**SAN ANTONIO WATER SYSTEM  
REGIONAL CARRIZO PROJECT  
BUCKHORN WELLFIELD COLLECTION PROJECT  
SAWS JOB NO. 03-8518-207  
SOLICITATION NO. B-12-021-DB**

**ADDENDUM NO. 1  
MAY 4, 2012**

PIPE DRAIN STRUCTURE TYPE 1  
NTS

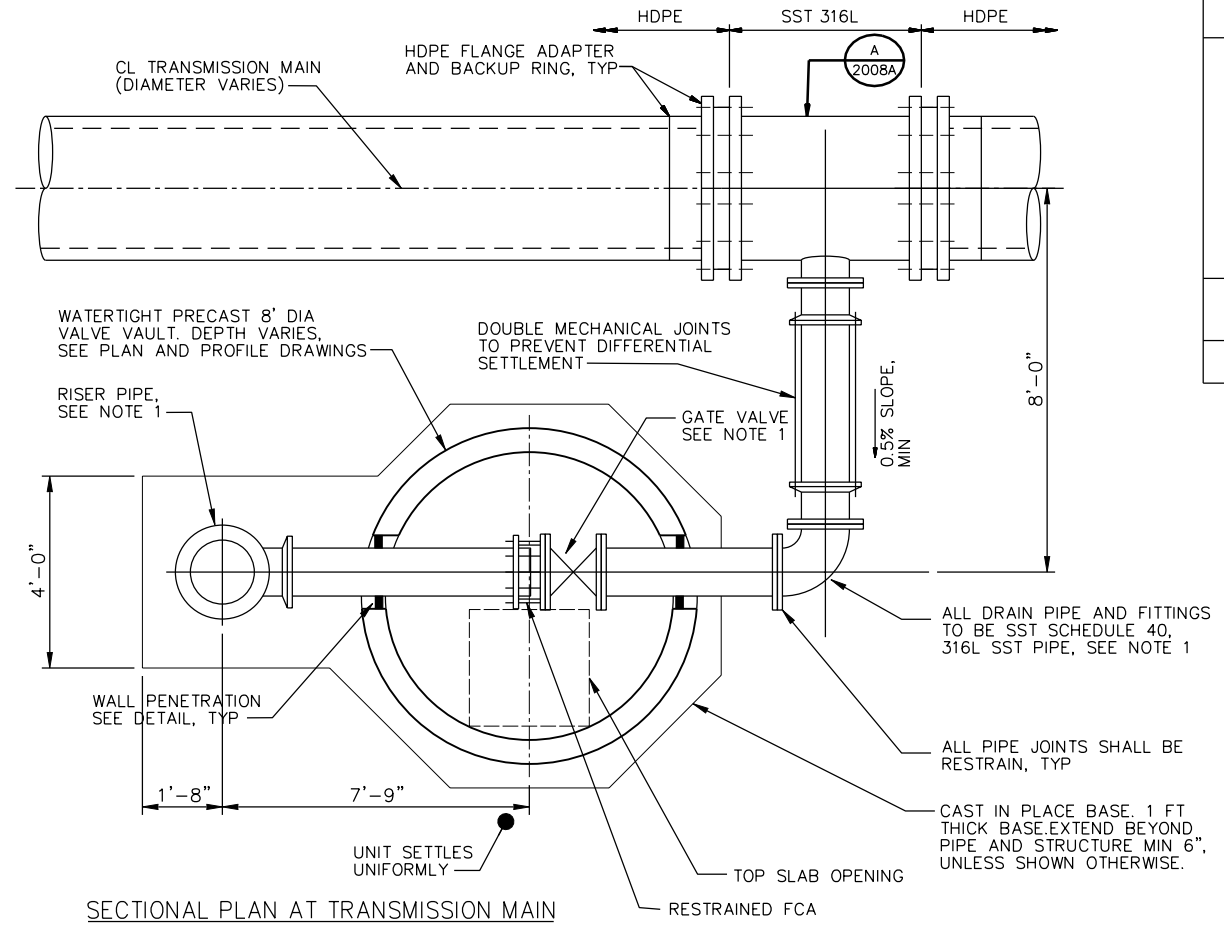
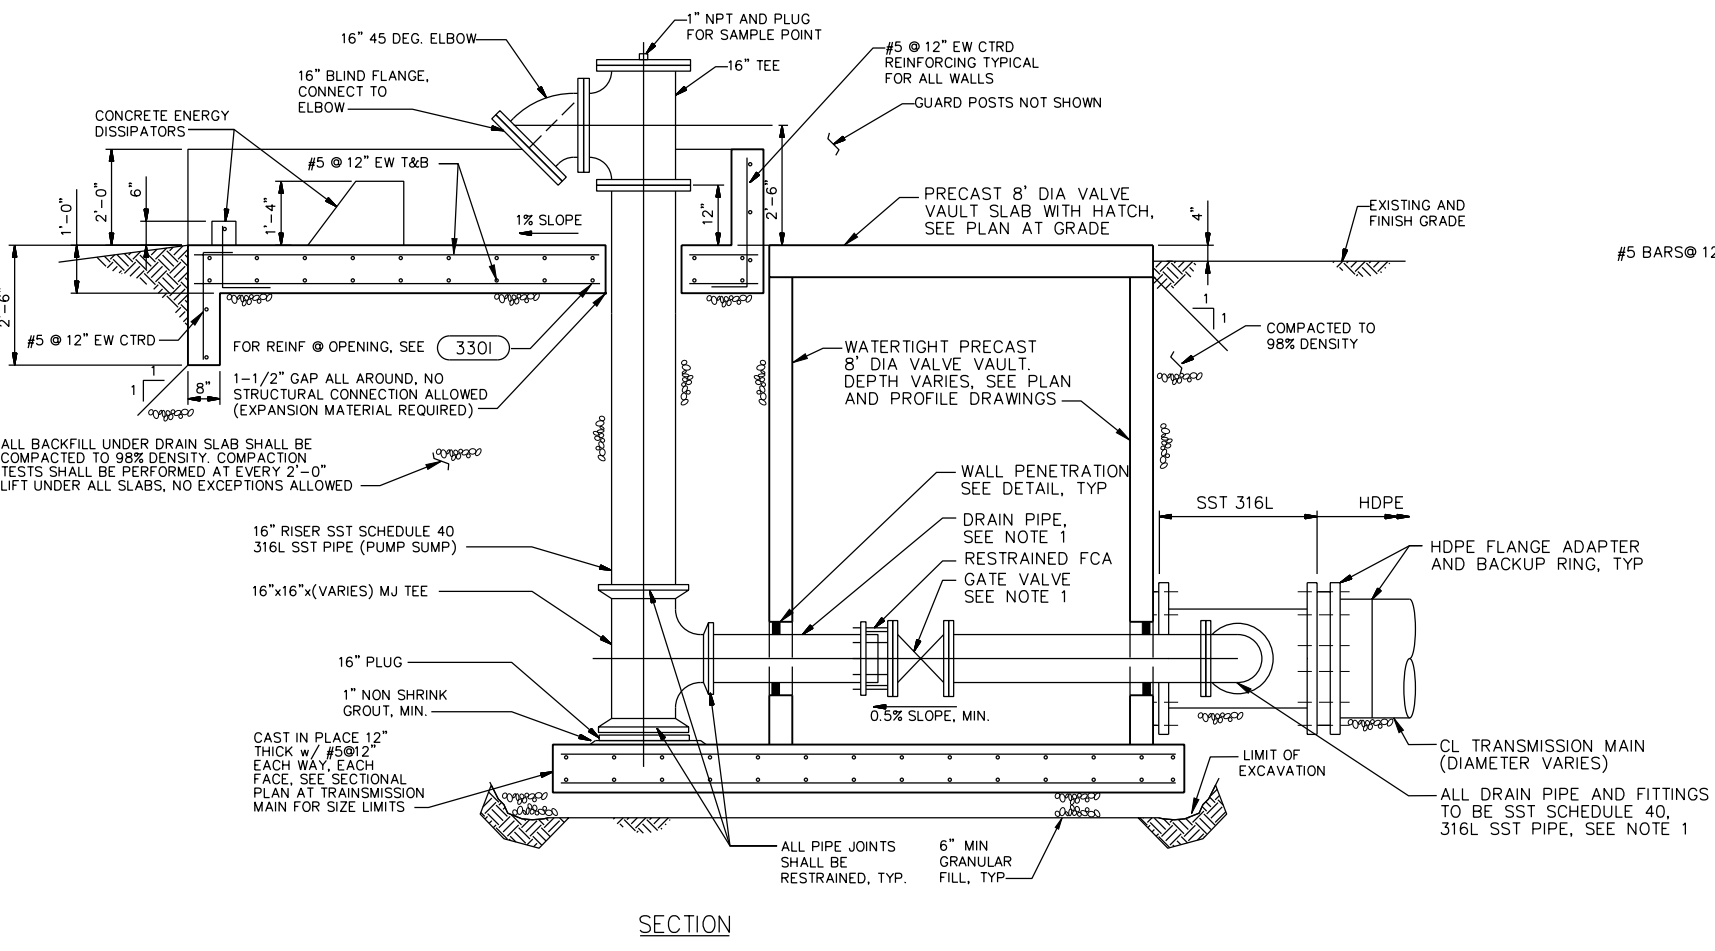
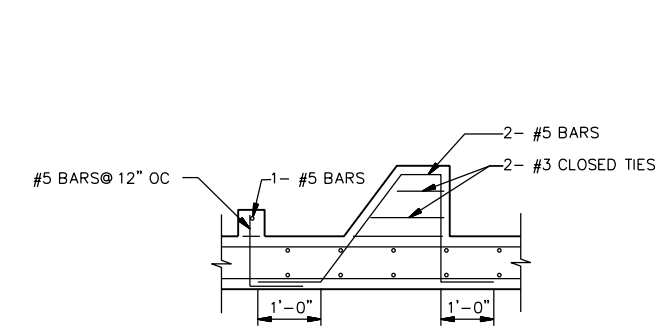
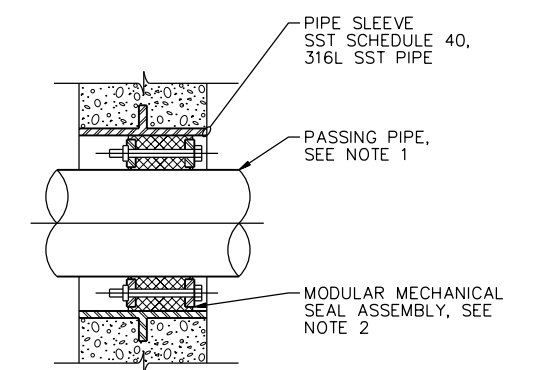
3. **Question:** *The proposal bid item #26 calls for (21) Pipe Drain Structures. The Plans detail that there are drains proceeding from (2) 36" HDPE RW Lines; (3) 30" HDPE RW Lines; (8) 24" HDPE RW Lines; (8) 18" HDPE RW Lines. On the RW Plan & Profile sheets there is no indication as to what size the drain line should be. Detail 2004A on Sheet 134 was not drawn to scale and does not indicate the drain pipe size. Nor does the detail show a profile view so as to determine the riser pipe's configuration (it also appears to increase in size at the splash pad). Can you clarify what size drain is required for each size HDPE RW Line? Can you provide a profile view of detail 2004A on Sheet 134 so as to clarify configuration and possible increase in size?*

18. **Question:** *On detail 2004 (Pipe Drain) what is the size of that line coming from the main? Detail on sheet 134 does not indicate the size.*
